MARTIN COUNTY, FLORIDA DEVELOPMENT REVIEW STAFF REPORT

STORAGE RENTALS OF AMERICA (Eastridge Estates PUD Block I, Lot 21) PUD FINAL SITE PLAN

5' RIGHT-OF-WAY DEDICATION

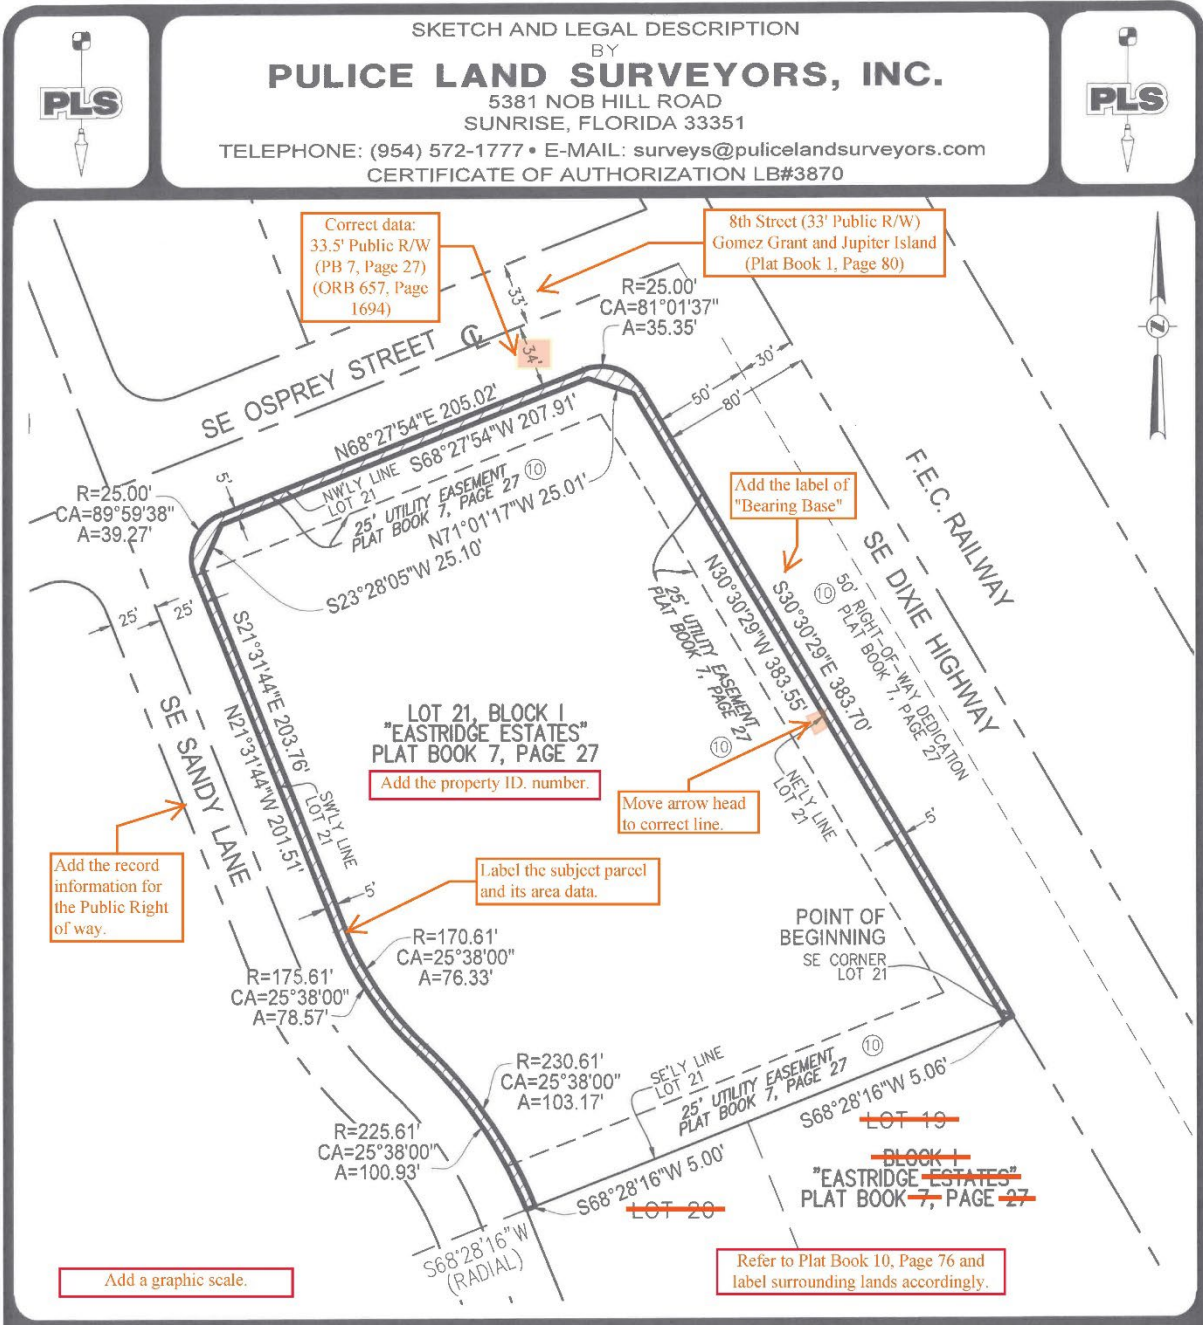
Add the missing abbreviations herein.
